Service Bulletin

Bulletin No. 2015-05R1
OEM No. 2015-04R1

Verado Product Improvement

Models Covered	Serial Number or Year
200–300 Verado	2B144123 and above

CDS G3 Diagnostic Tool Version Compatibility

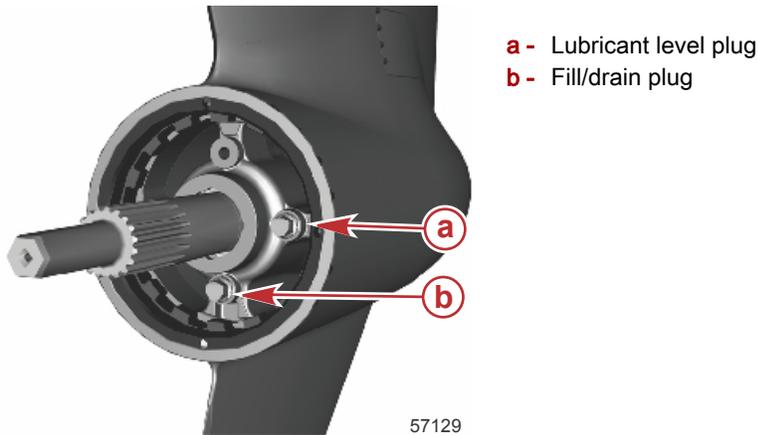
CDS G3 release 1.6.1 is compatible and has similar functionality as experienced with previous Verado models using CDS.

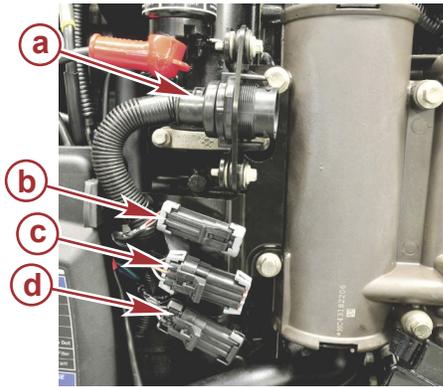
1. There is a new fuel supply module (FSM) based on the 150 FourStroke fuel system architecture. Refer to the operation manual or installation manual for priming the FSM.
2. A new boat-mounted water-separating fuel filter is included with the engine. This filter has a larger media area for capturing contaminants and an increased water separating capability with a removable water sensor. This filter has replaced the engine-mounted fuel filter.
3. An in-line fuel filter is located inside the engine side fuel line connector, and it is required when a boat-mounted fuel filter is installed. This filter captures debris that may be in the fuel line between the boat-mounted filter and the fuel line connection on the engine. This filter can be removed or replaced after one year or 100 hours of operation.

57973

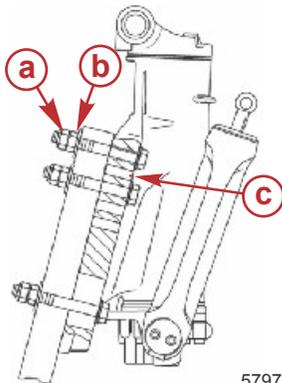
This engine requires six mounting screws secured with two nuts on each screw. The top screws must have one vacant transom mounting bracket hole between the screws. Only one locknut per screw is allowed.

57255

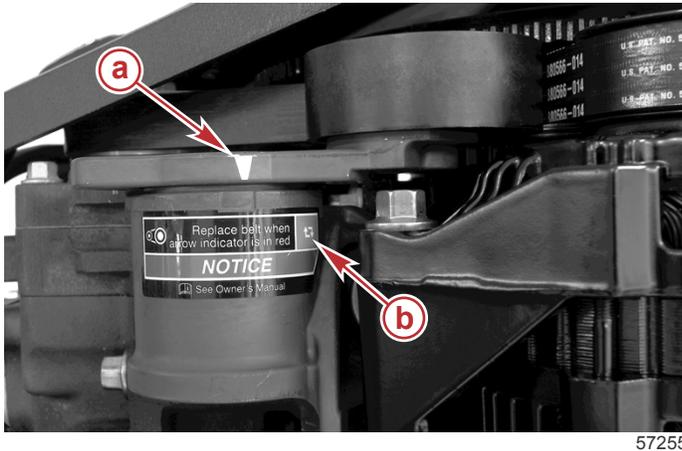
2. **Accessory drive belt**—A decal placed on the accessory drive belt tensioner base allows for a quick evaluation of the overall belt length. When the arrow on the tensioner is pointing to the red target window on the decal, the belt should be replaced.

- a - Tensioner arrow
b - Red target window (replace the belt)
